Project #21-81

Stable Ridge Apartments- Response to Staff Comments
American Development Group
555 Court Street, Auburn, ME

Comments from John Blais from Staff Review Meeting dated March 17, 2022:

Alternate analysis of driveway

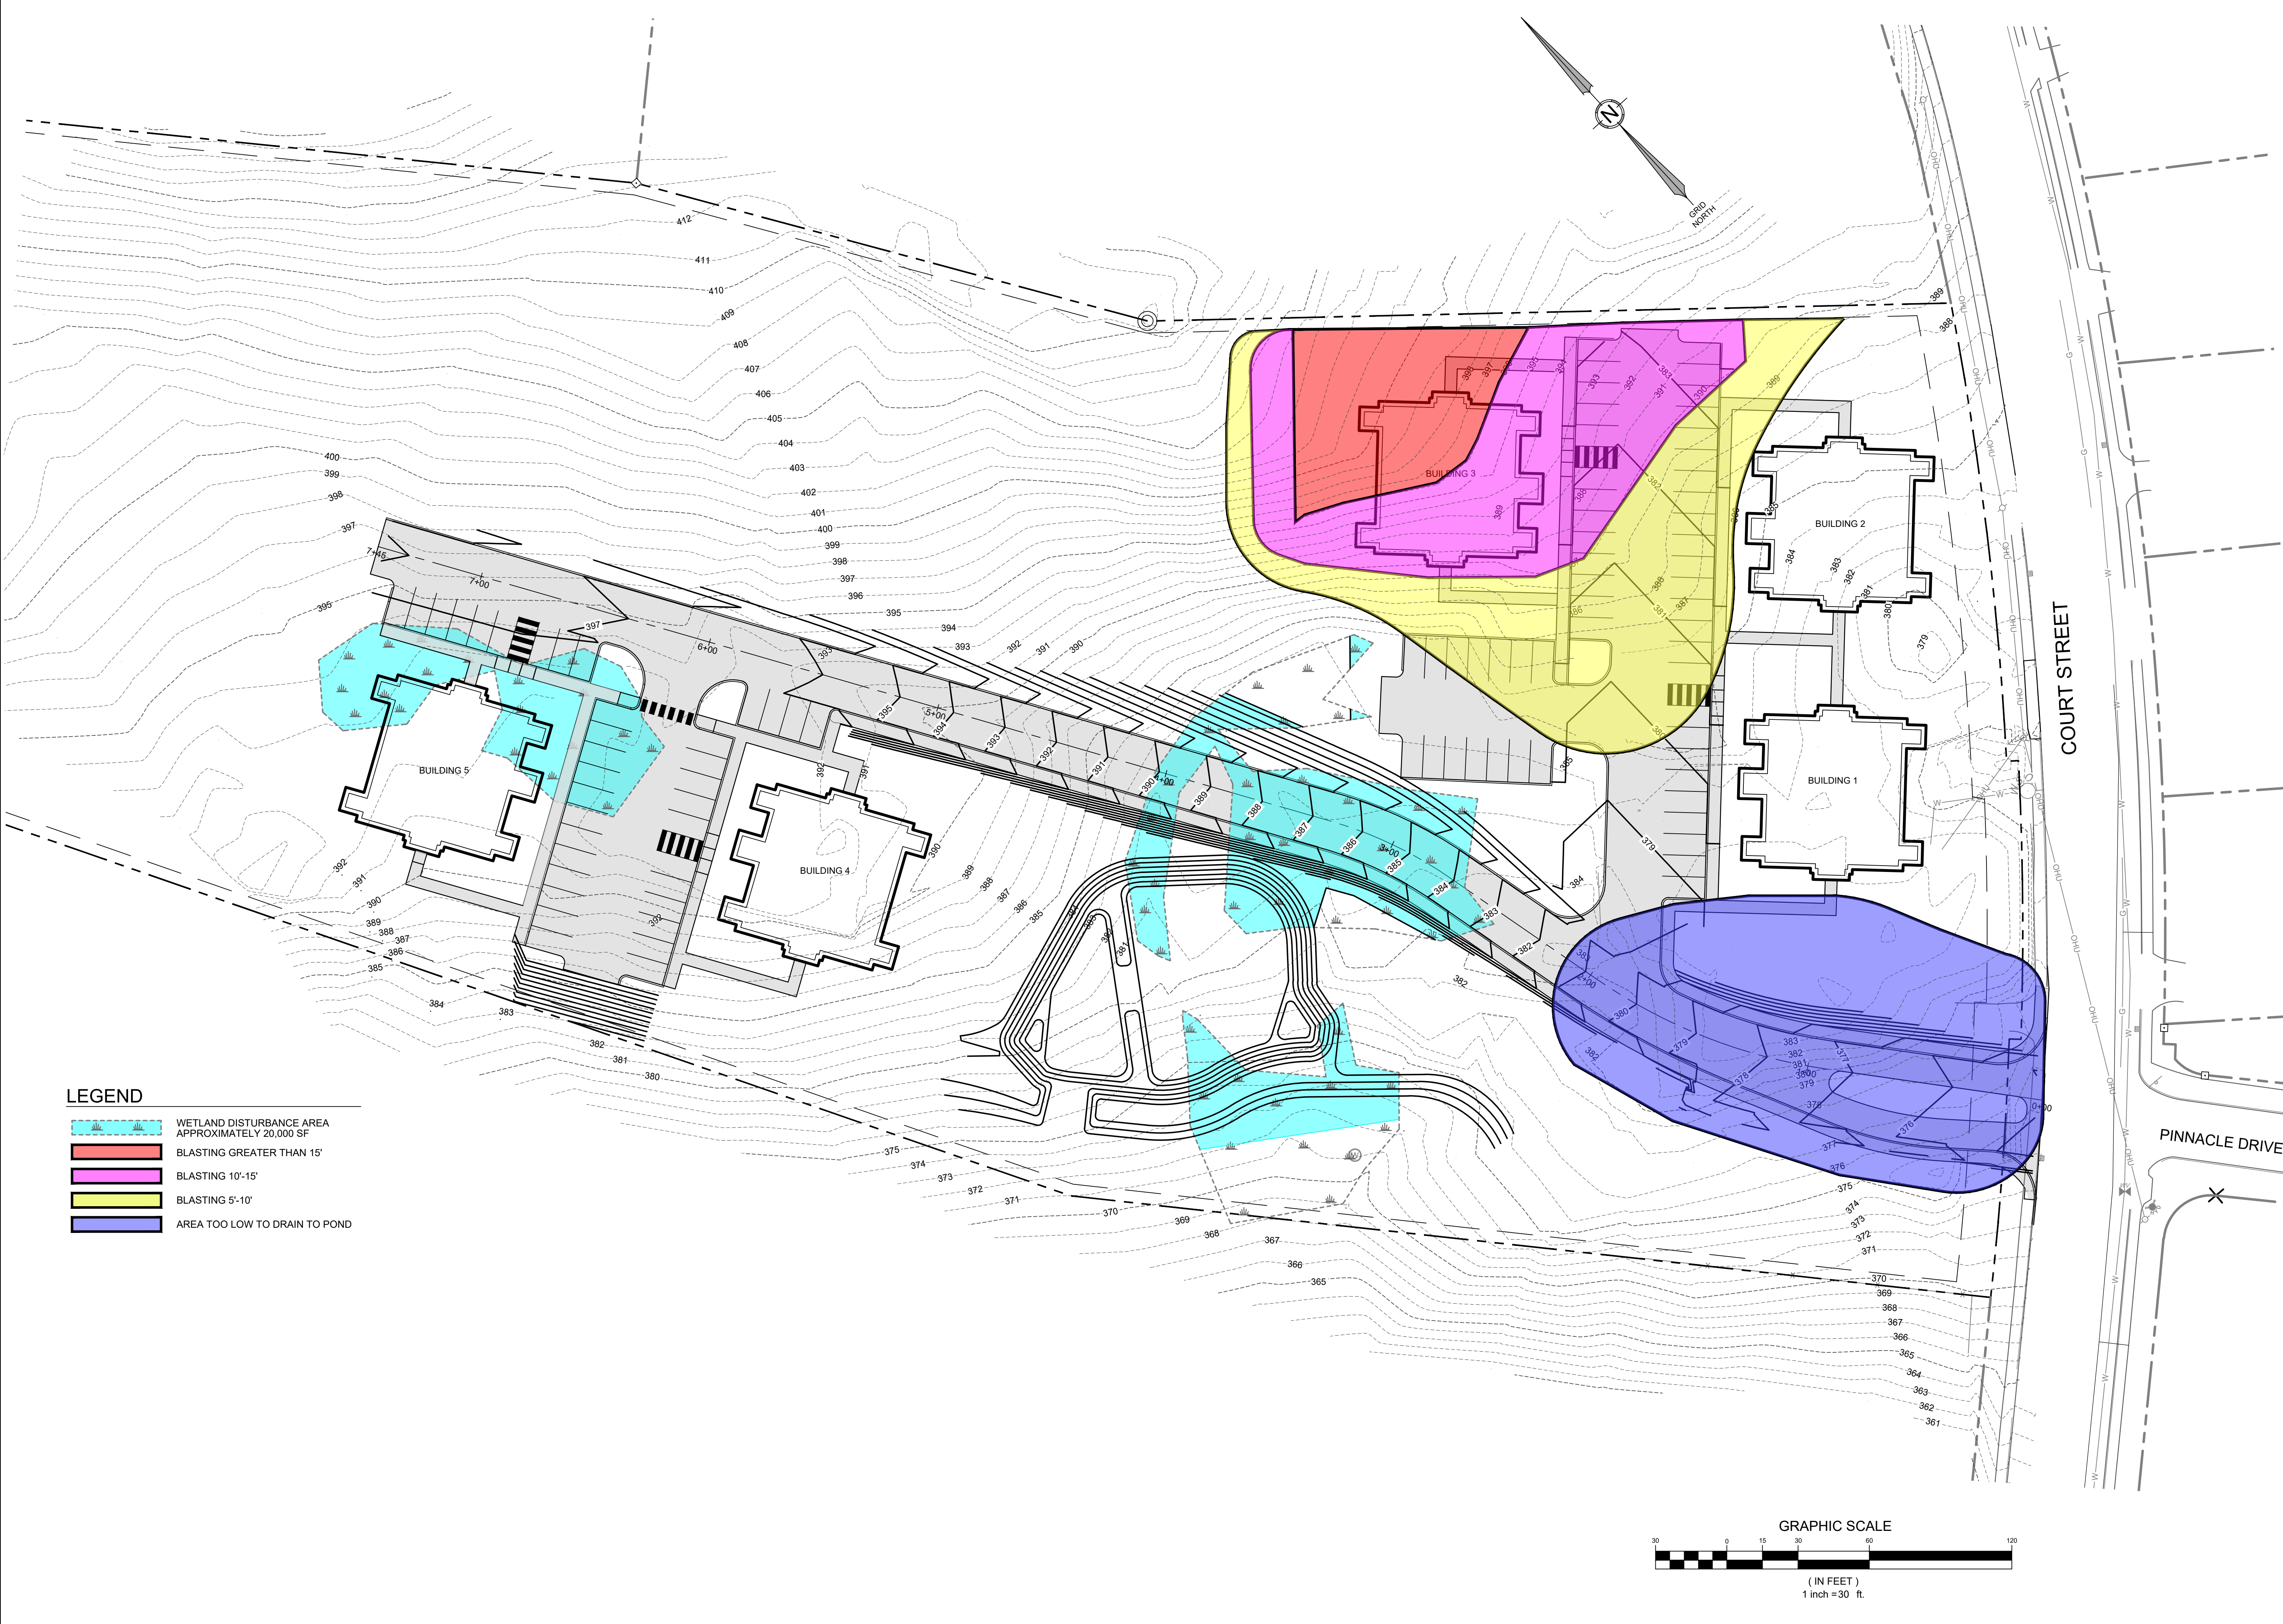
5. *Investigate relocating entrance alignment with Pinnacle Drive*

Comment Response: During the initial concept design phase, our office had looked extensively at different configurations of the entrance on the site before choosing the proposed option. Three key components were analyzed

Attached to this letter is a Figure showing the approximate location of the drive shifted and with

PROJECT: STABLE RIDGE APARTMENTS 555 COURT STREET, AUBURN, MAINE	CLIENT: AMERICAN DEVELOPMENT GROUP PO BOX 1495 NAPLES, MAINE 04055
SHEET TITLE: OVERALL SITE PLAN	DATE: 1/3/2022
	SCALE: 1"=60'
	DESIGNED: CMS
	JOB NO.: 21-81
SHEET	C-1.0

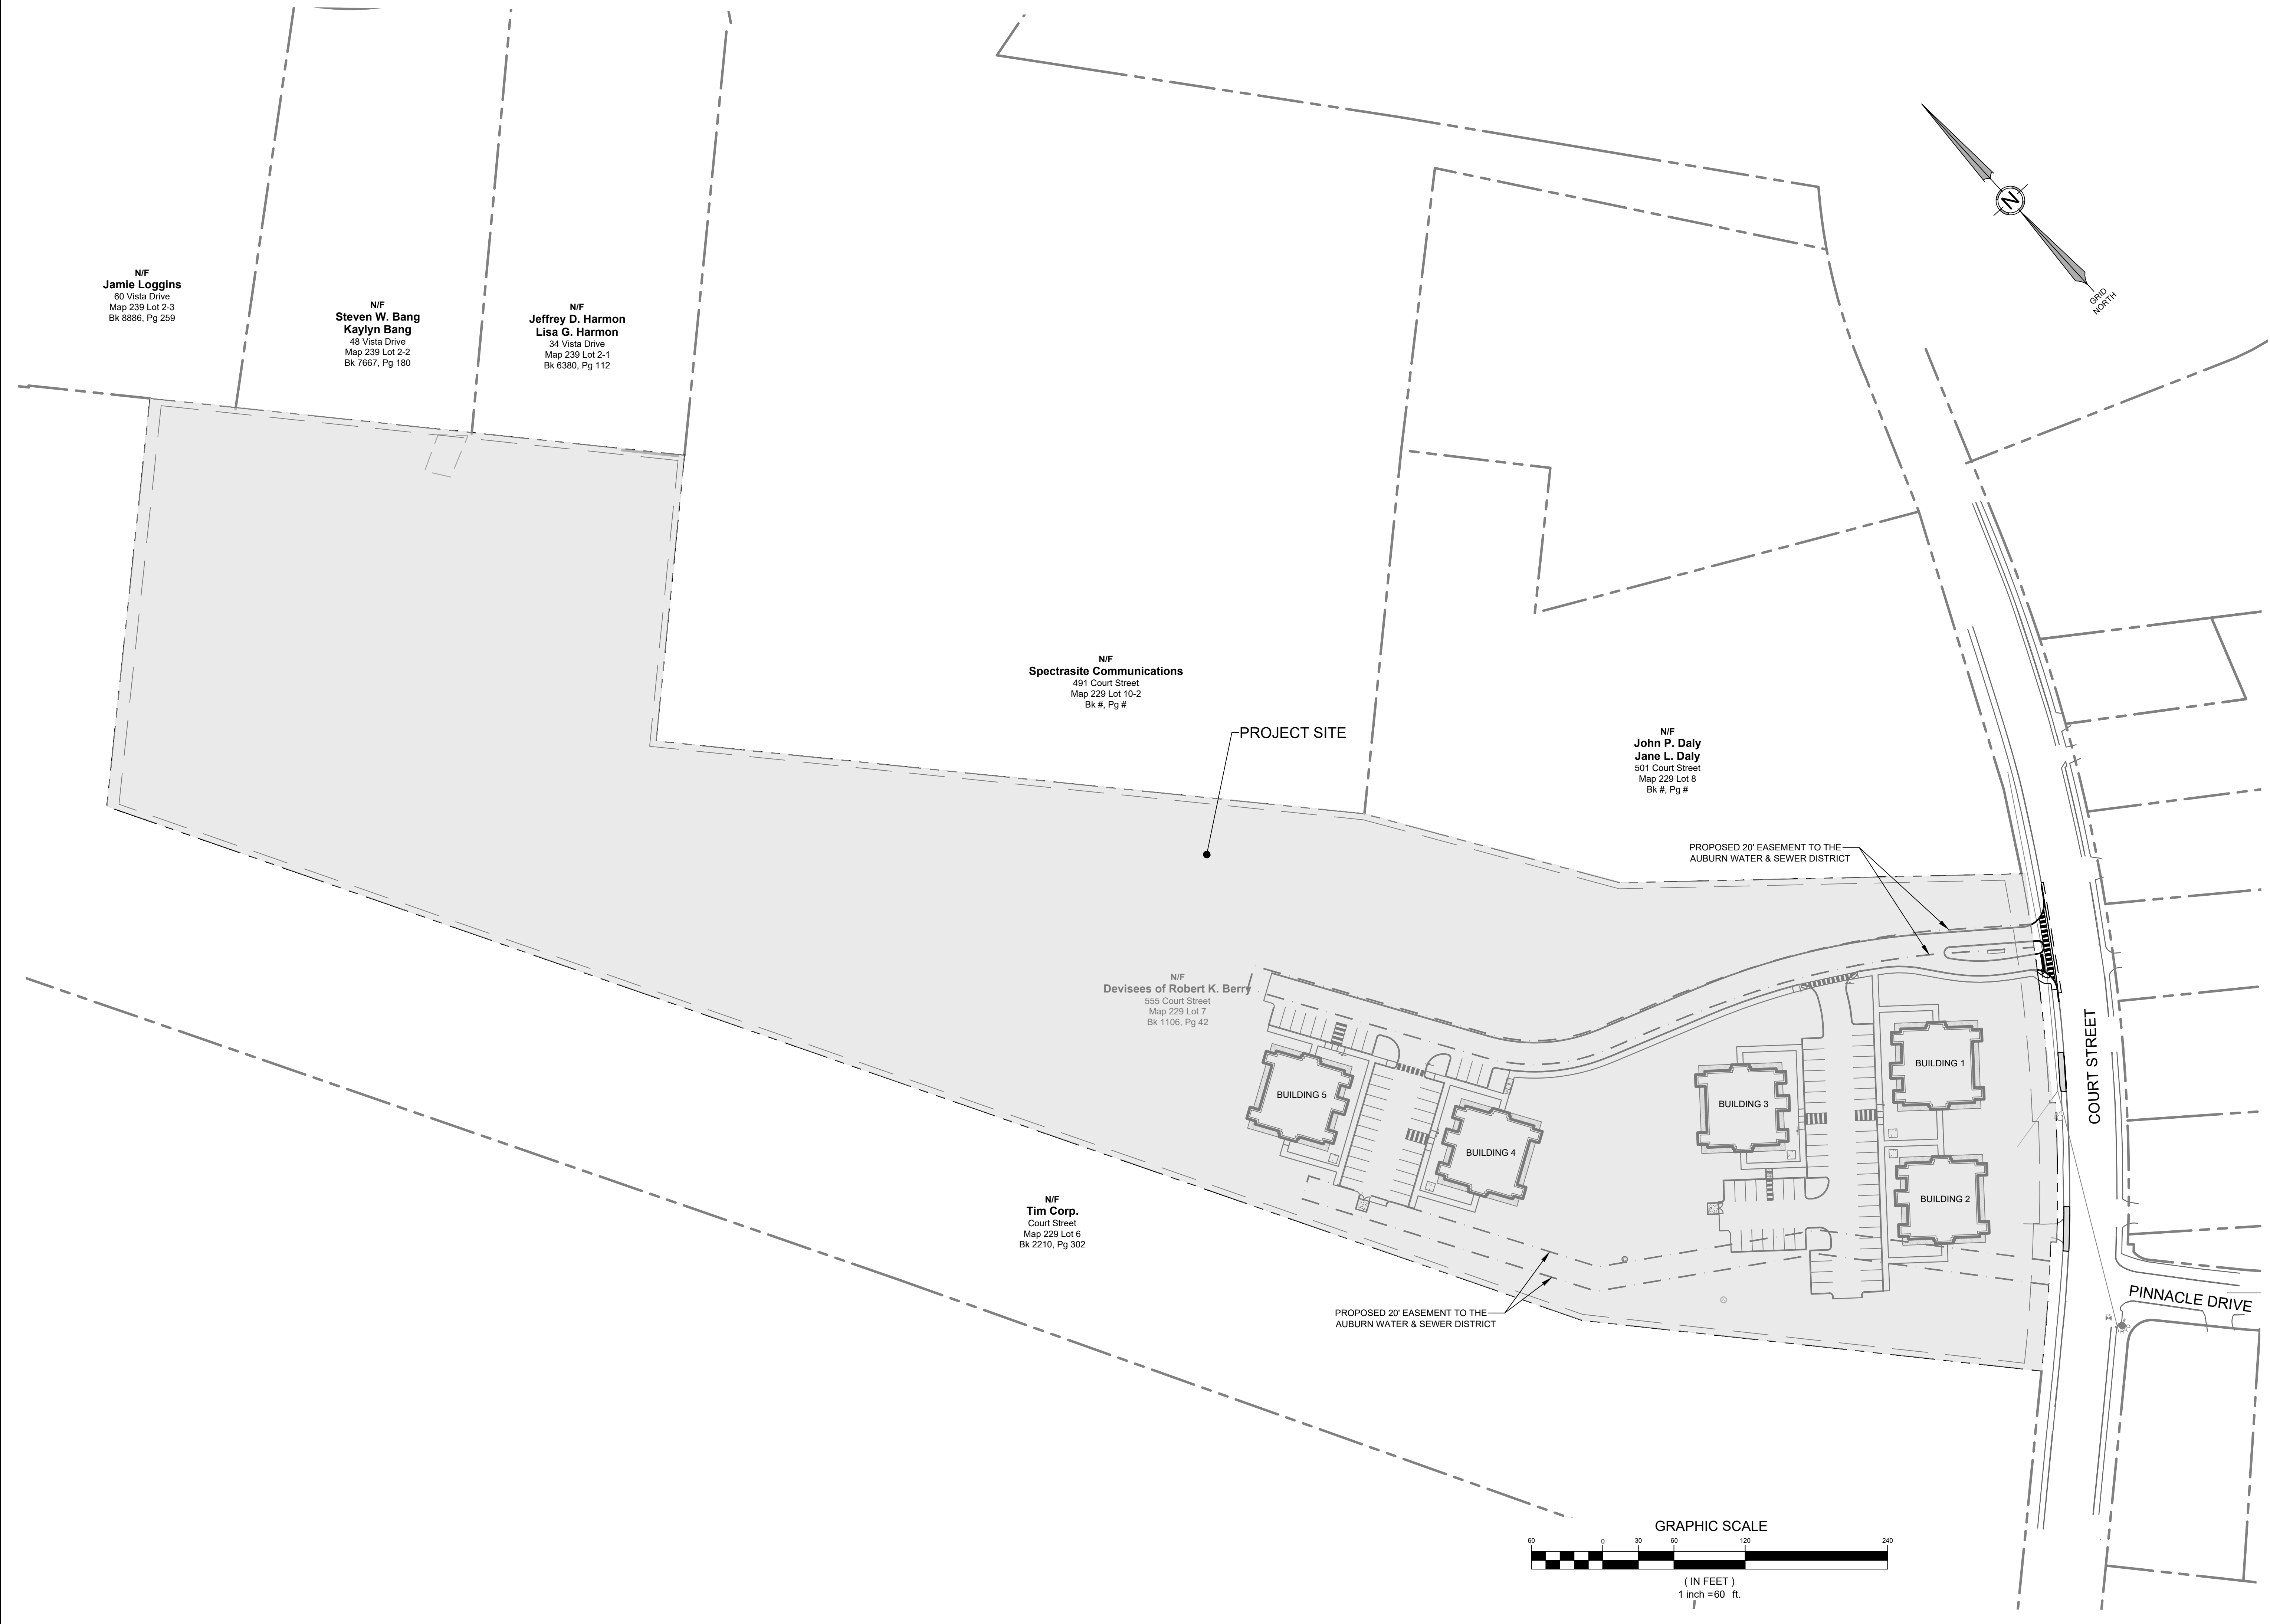
6. *Provide comment on how the proposed entrance will not affect the abutter across the street.*

9. *Please provide a comment as to why different roads are required. The entrance travel land we typically see a minimum 20' you may be off eliminated the separate 12' entrance because that will become problematic for emergency vehicles.*

Comment Response: The proposed entrance drive has been shifted so that the exiting traffic lane aligns with the abutter across the street. The second turning lane has been eliminated.

Comment Response: The entrance and exiting lanes are separated by a landscaped island to help visually set the entrance apart. Please see the attached turning figures demonstrating that the City of Auburn Fire trucks can adequately access the proposed entrance.

Comment Response: The width of the entrance has been shortened by the removal of the second turning lane. There is a 10' section between the entrance and exit drives that can be used as a relief point for pedestrians.
